Subject: Corrections / Clarifications to the Exelon Early Site Permit (ESP)
Application Environmental Report for the Clinton ESP Site (TAC No.
MC1122)

U.S. Nuclear Regulatory Commission
November 16, 2004, Enclosure 1

Enclosure 1: Corrections / Clarifications to the Environmental Report of the Exelon
ESP

Figure 2.3-3 Postdam Peak Flood Magnitudes and Frequencies for Salt Creek at Rowell Gauge Station

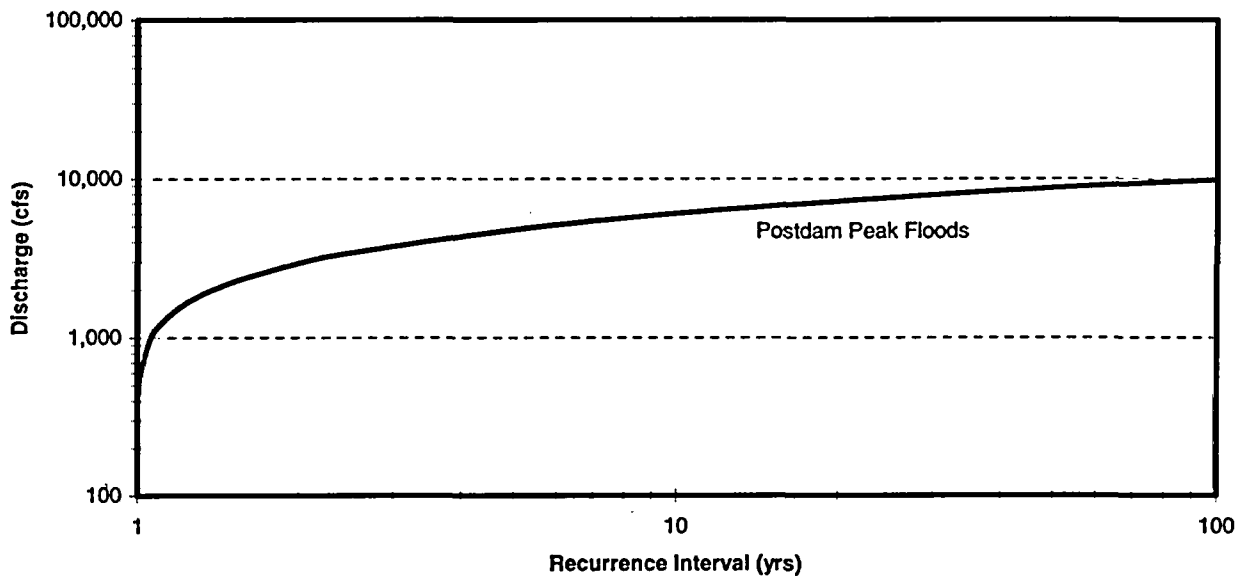
The flood frequency estimations for the Rowell gauge were re-examined based on discussions with the NRC during their site audit and the SSAR RAIs where NRC noted minor discrepancies with the discharge data. EGC has reviewed the statistical analysis of the historical discharge data at the Rowell gauge and identified areas to be revised. In summary, the period of record for the historical data was updated as more data are now available than at the time of the original analysis (analysis now includes Water Years 1979 through 2003); and EGC has revised the latitude and longitude of the input to the USGS DOS-based program (Peak FQ) which is the Log Pearson Type III analysis as described in WRC Bulletin 17B to more closely reflect the location of the gauge.

4. Replace Figure 2.3-3 with:

Flood frequency for the Rowell gauging station were calculated using a Log-Pearson Type III distribution based on the 25 years of records from Water Year 1979 through 2003. Figure 2.3-3 shows the peak flood frequency curve for Salt Creek at the gauging station under post-dam conditions. The peak flow for various recurrence intervals at the gauging station and at the dam are also shown in Table 2.3-4. The discharges at the dam site were derived using the drainage area ratio.

Environmental Report for the EGC Early Site Permit
Figure 2.3-16
Location of Piezometers, CPS
Test Well, and Water Table
in Site Vicinity

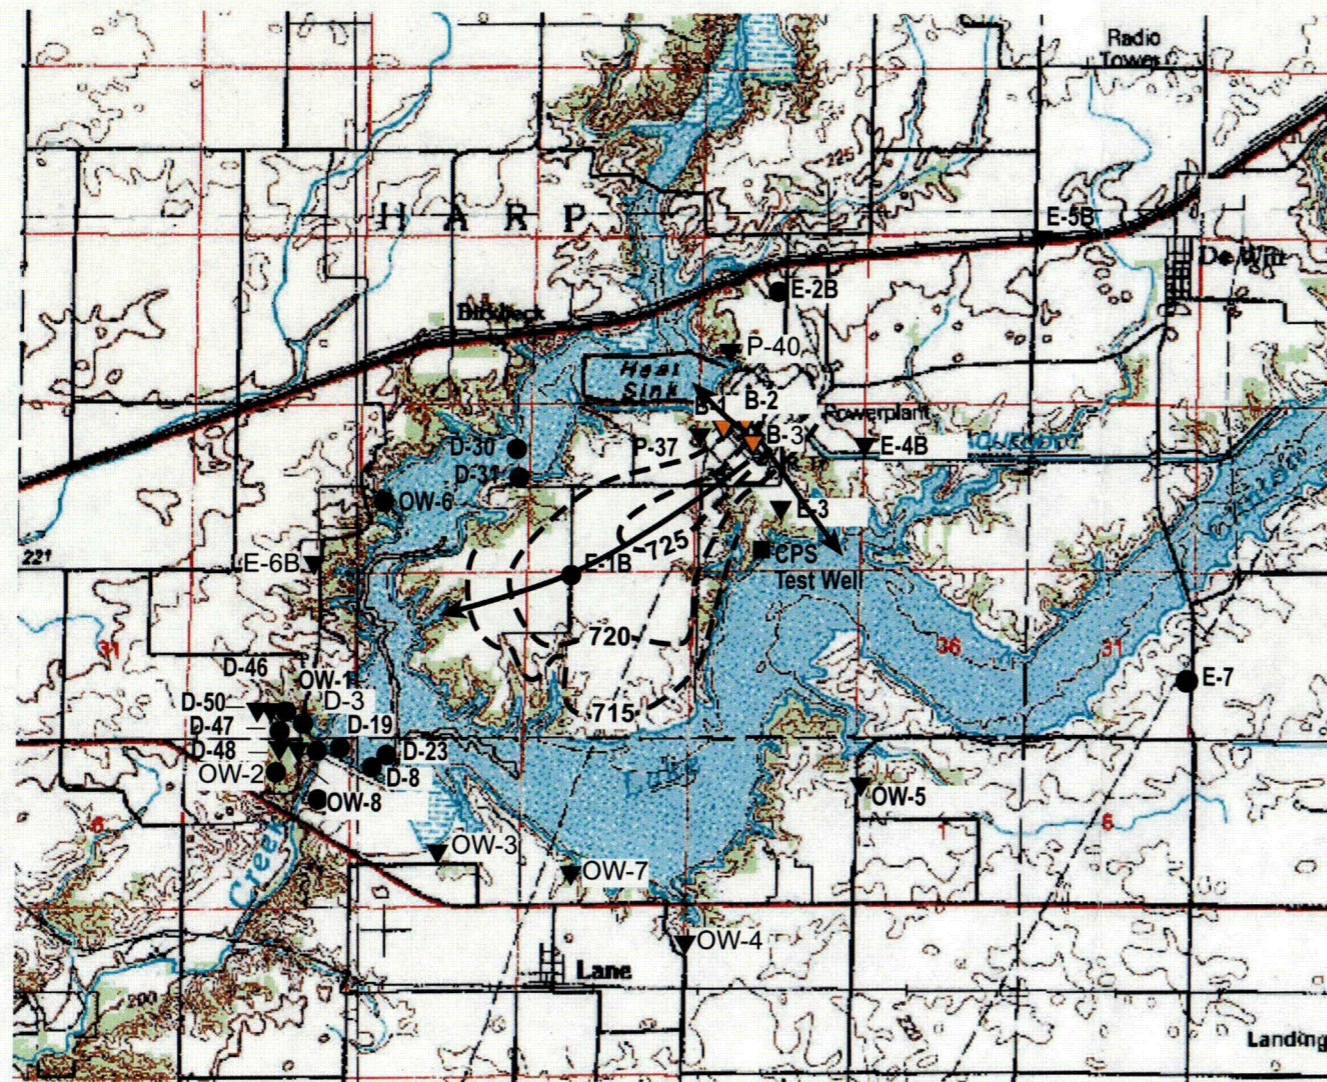
Water table elevations shown on the figure were incorrect (not consistent with the flow arrow). Elevations on Figure 2.3-16 were modified by switching the "715" and "725" contour levels.

1. Replace ER, Chapter 2, Section 2.3, Figure 2.3-16 with Attachment 1
